SUBJECT: Forwards addl info re mod to main feedwater lines to steam
 generators D2/D3, to alleviate certain forward flushing
 transients, per NRC 830218.

Re: McGuire Nuclear Station, Unit 1
Docket No. 50-369
D2/D3 Steam Generator Design Modification

DUKE POWER COMPANY
McGUIRE NUCLEAR STATION, UNIT 1
D2/D3 STEAM GENERATOR DESIGN MODIFICATION
RESPONSE TO REQUEST FOR ADDITIONAL INFORMATION

Fig. 1 Startup Valve Positions (with warmup line in operation)

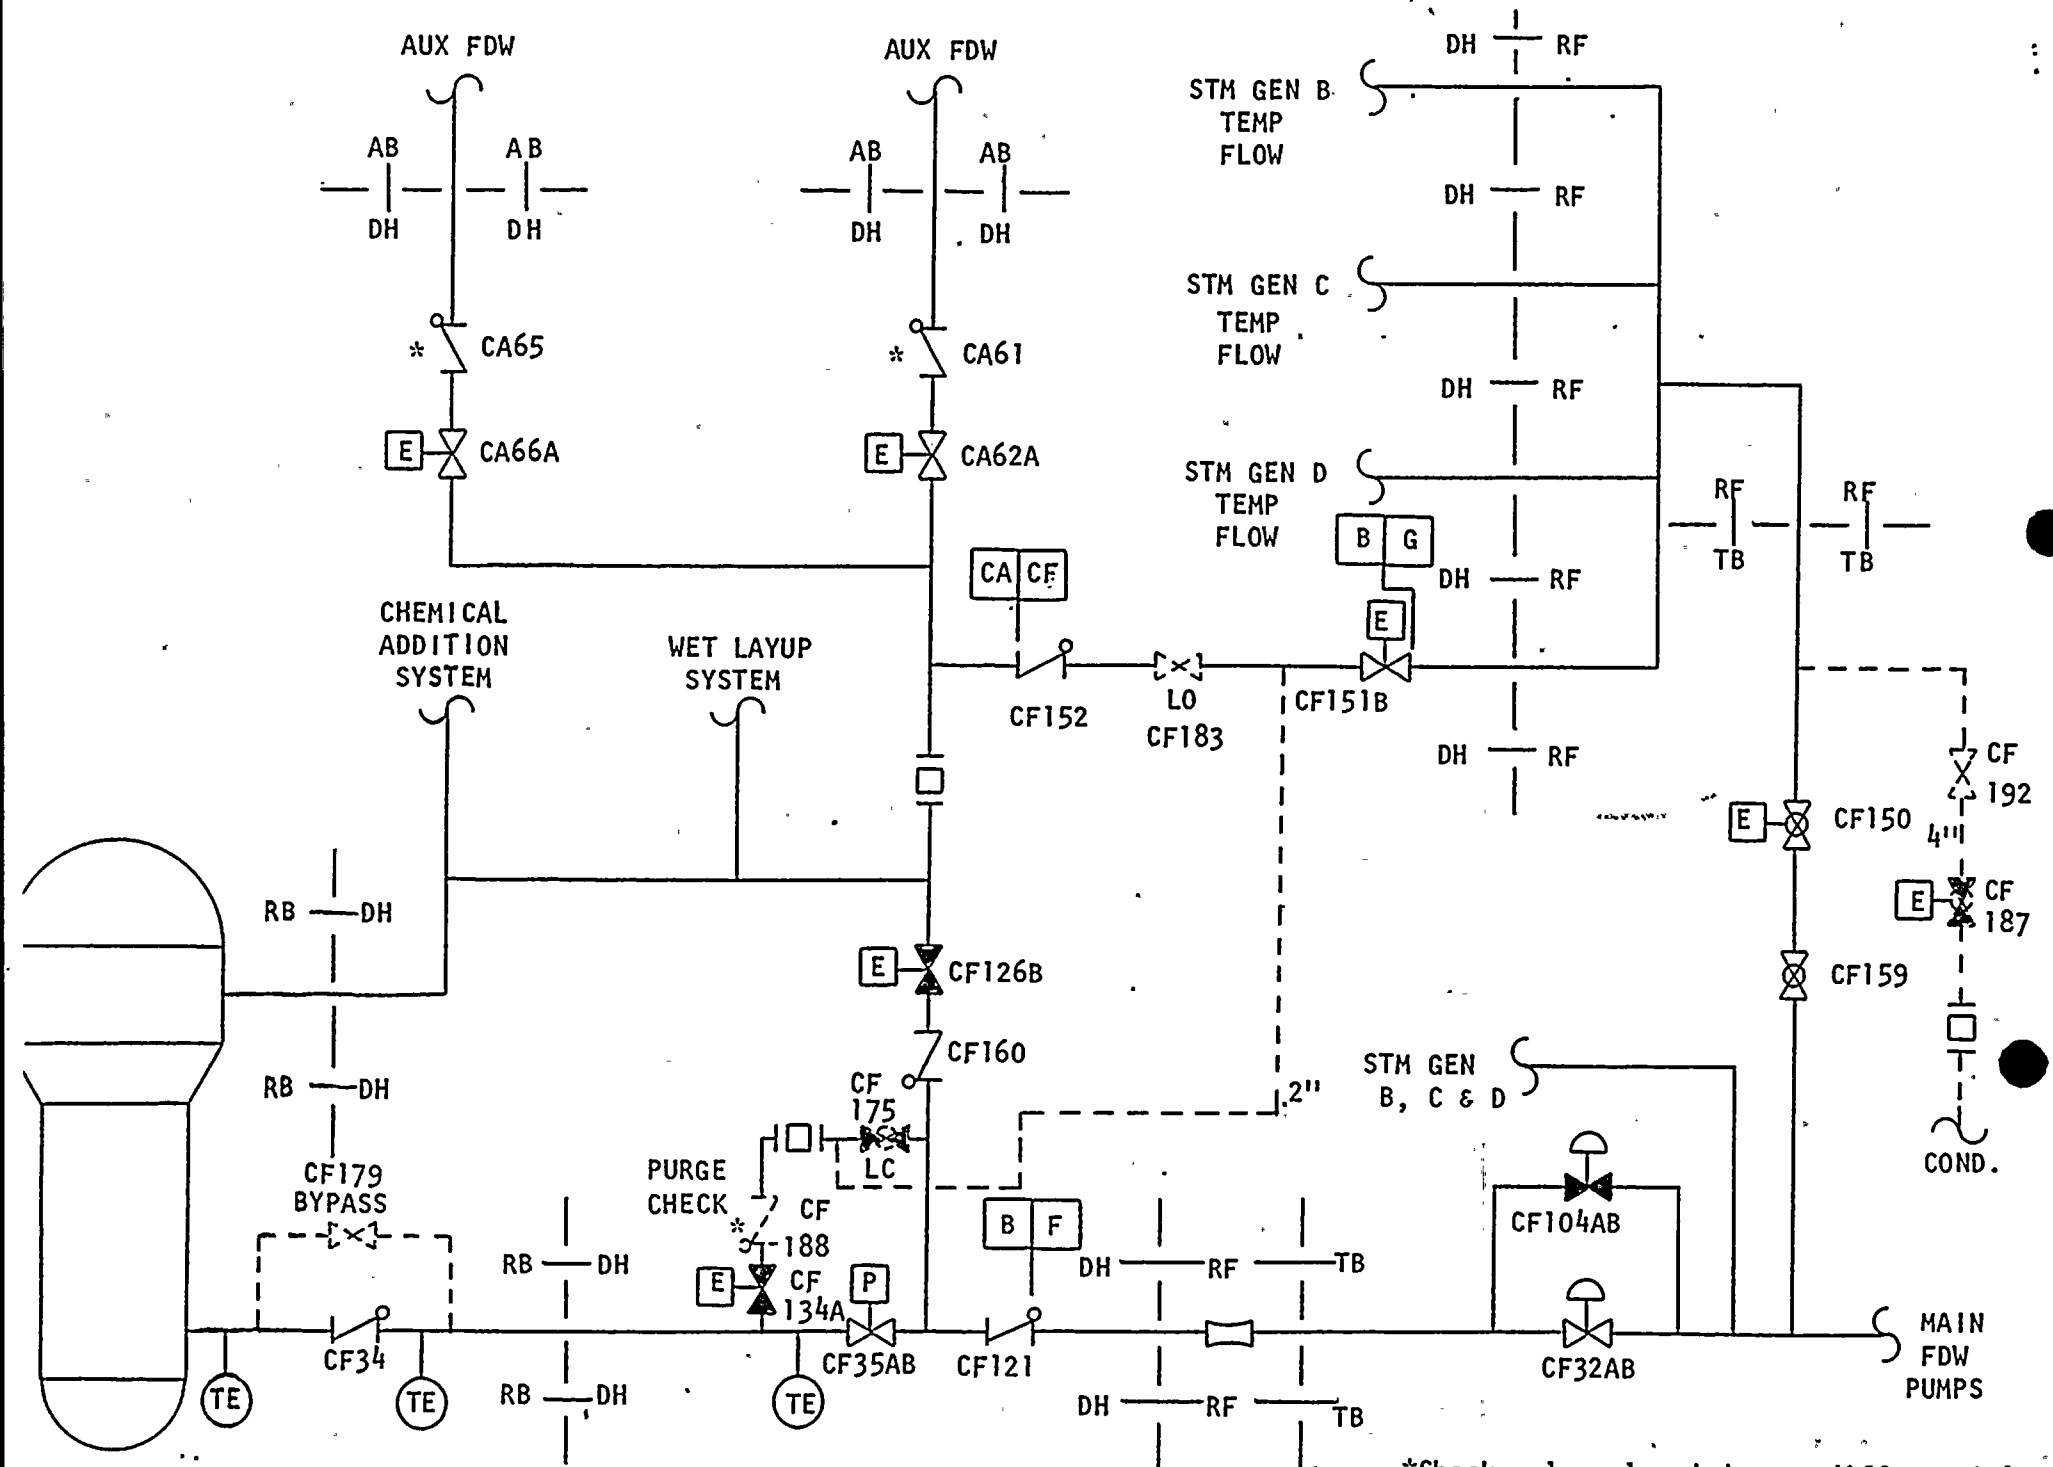
1. Q. Figure 2 attached to the utility's submittal dated February 3, 1983 does not indicate the normal position of the valves. Provide a figure which shows the normal position of the valves during startup (with the warmup line in operation) and a figure showing the valves in the normal full power configuration.

A. See Fig. 1 for valve positions during startup with the warmup line in operation.

See Fig. 1. New piping and valves shown by dotted lines. Building boundaries also shown.

A. Refer to Fig. 1 for discussion of A steam generator (typical)

Main feedwater flow is supplied to the auxiliary feedwater nozzle through valves CF121 (feedwater check valve), CF160 (feedwater preheated bypass check valve) and CF126B (feedwater preheater bypass valve). Flow is regulated by the control bypass valve CF104AB below 15% power and by the control valve CF32AB otherwise. The feedwater isolation valve CF35AB is closed to prevent flow to the main nozzle. Valves CF134A, CF151B, and CF150 are closed and CF187 open to prevent flow to the main nozzle through the warmup line prior to initiating warming.

To initiate warming, valves CF134A and CF151B are opened to pressurize piping. Pressurization rate and purge flow are controlled by orifice downstream of CF188. After opening above valves, valve CF187 is opened to initiate flow. Thermocouples downstream of valve CF35AB and upstream of CF34 are monitored to determine that temperatures are satisfactory to initiate forward feedwater flow through the main nozzle.

When temperature limits are met on all steam generators valve CF187 is closed. Valve CF134A is then closed.

Valve CF150 is then opened to provide tempering flow to the auxiliary feedwater nozzles through valve CF151.

A. See Fig. 1 for discussion of A steam generator.

A. All piping and valves inside the Doghouses and Reactor Building are protected against tornado missiles and tornadoes. Piping and valves outside doghouses and Reactor Building are not protected. See Fig. 1 for building boundaries. Loss of these unprotected components concurrent with the loss of offsite power and the most limiting single failure will not result in unacceptable consequences.

A. Refer to Fig. 1 for a discussion of Steam Generator A.

FIGURE: CAP-A-1

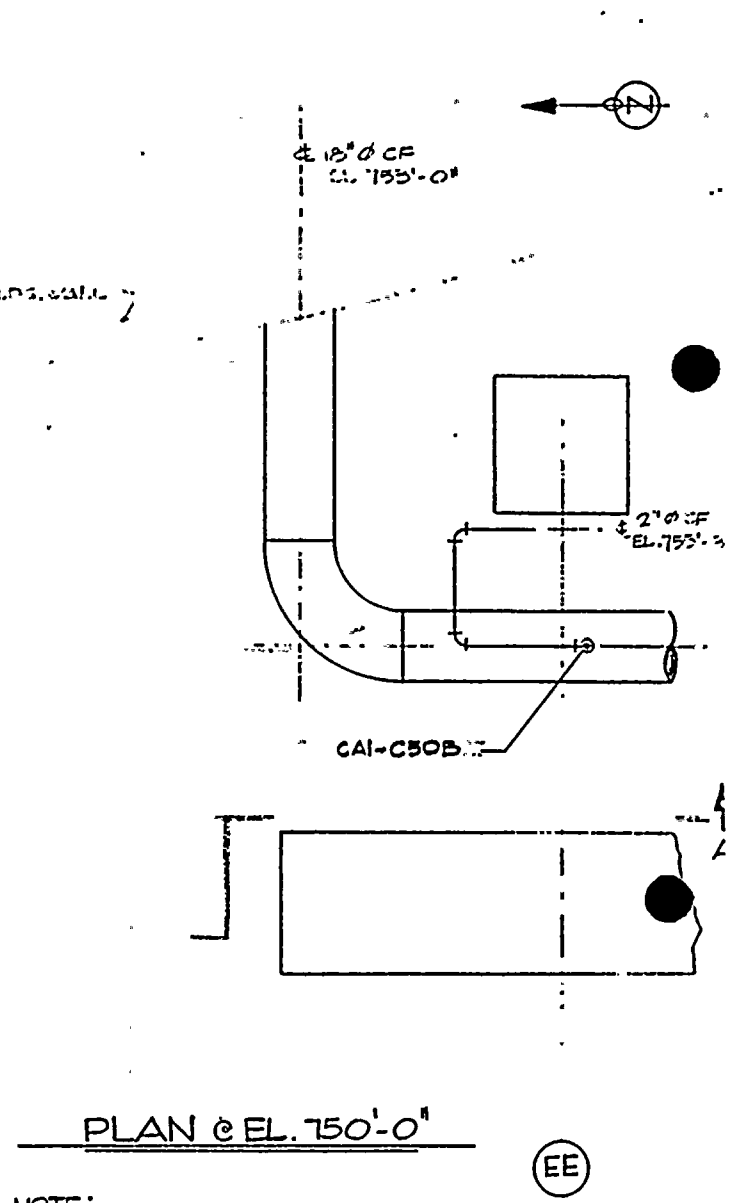
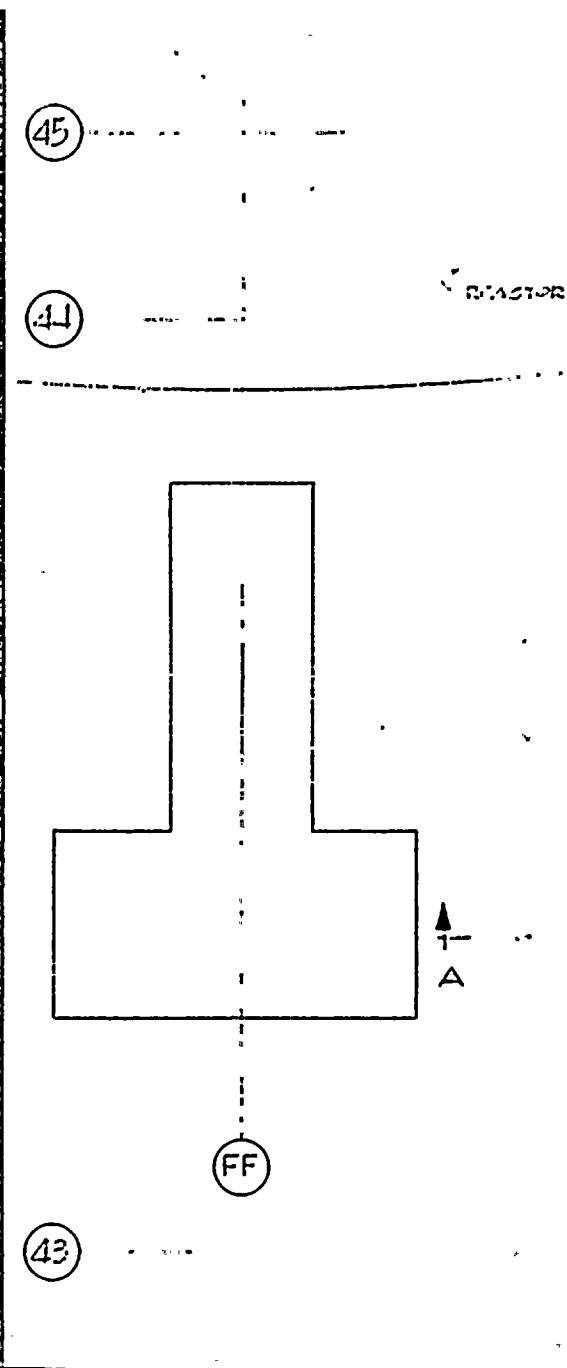
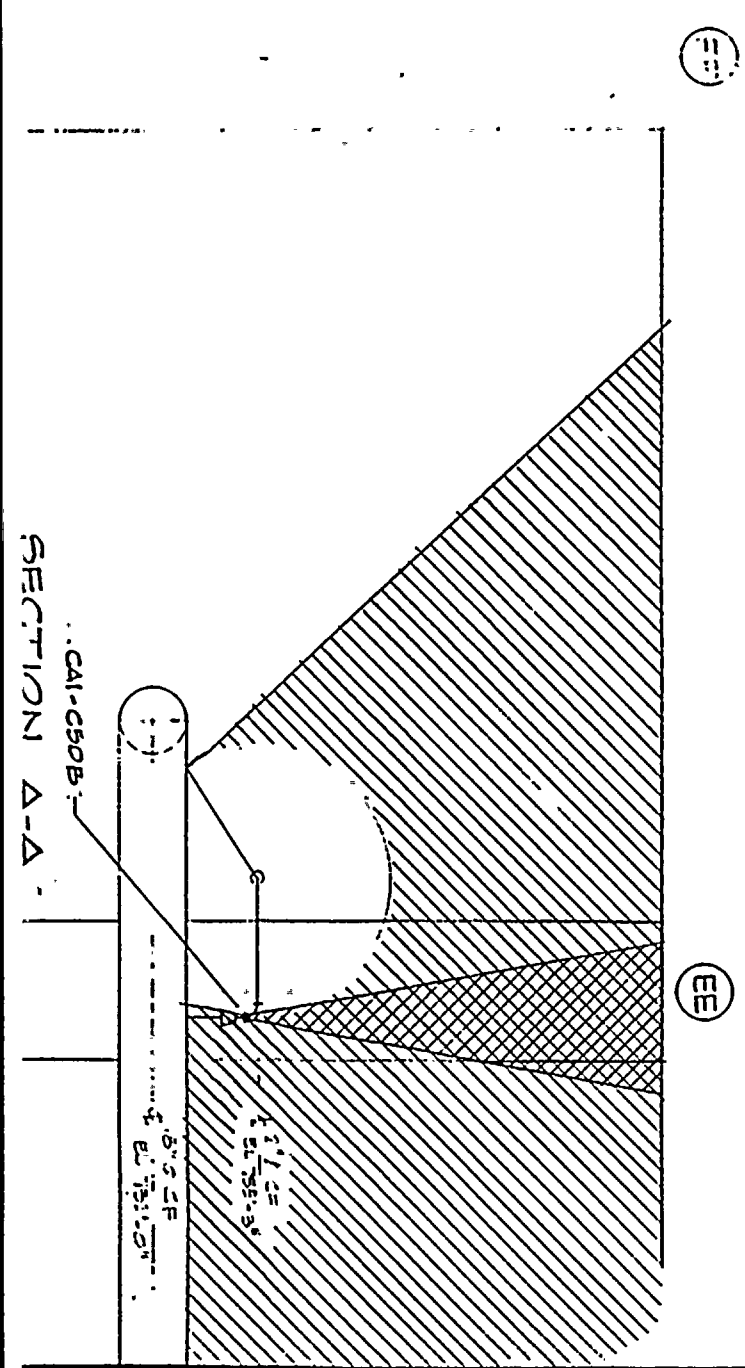
8. Q. Since the piping valves will be subjected to a temperature higher than 200°F or a pressure greater than 275 psig, provide the results of a high energy pipe break analysis in accordance with the Standard Review Plan Section 3.6.1. Provide drawings which show the piping configurations, postulated break locations, the jet cones which result from the escaping fluid, and the location of the pipe whip restraints. For those portions of the proposed system which do not have a temperature higher than 200°F and do not have a pressure greater than 275 psig, provide the results of the moderate energy pipe crack analysis in accordance with the acceptance criteria of Standard Review Plan Section 3.6.1.

Figures CAP-A-1 thru 4 and CAO-D-1 & 2 provide the jet cones which result from the escaping fluid issuing from the new break locations requiring protective devices.
